[Docket No. FAA-2025-2546; Project Identifier AD-2025-01060-T;

Amendment 39-23414; AD 2026-15-02]

Airworthiness Directives; The Boeing Company Airplanes

ACTION: Final rule.

Figure 2 to paragraph (i) – Fuel Feed Encapsulation

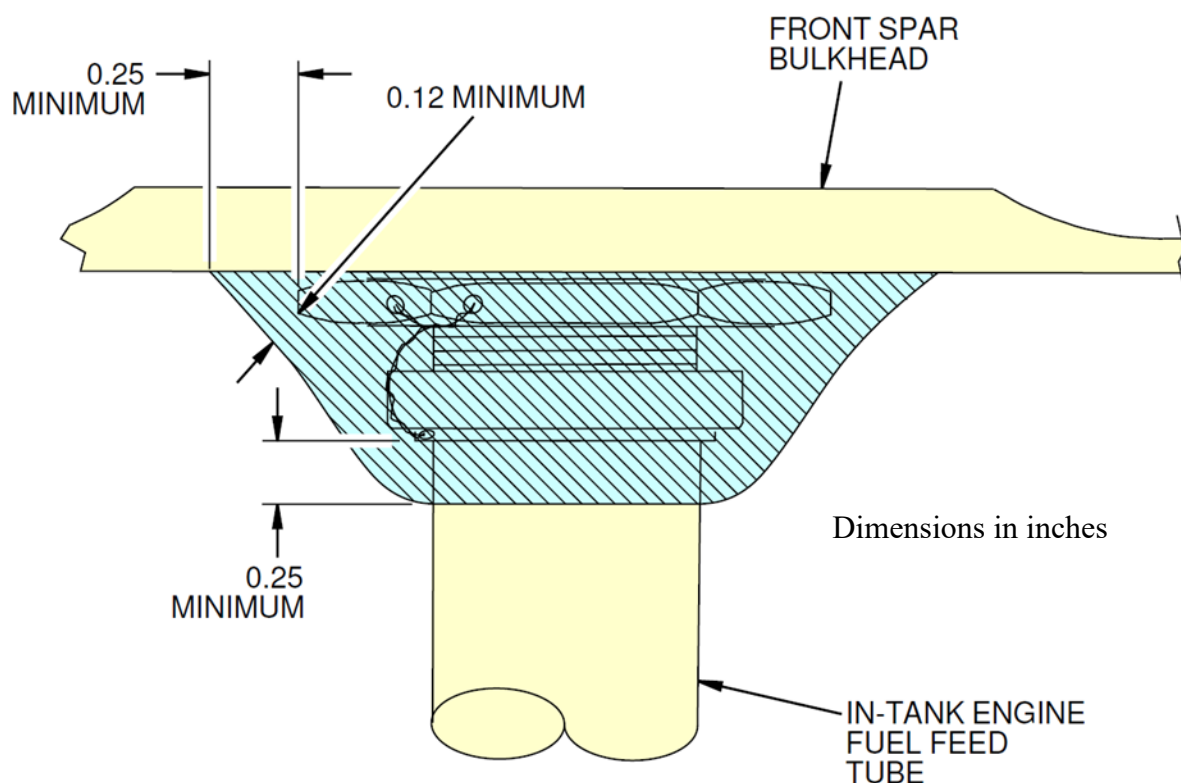
Within 60 days after the effective date of this AD, revise the existing maintenance or inspection program, as applicable, to incorporate the information specified in Figure 1 and Figure 2 to paragraph (i) of this AD.
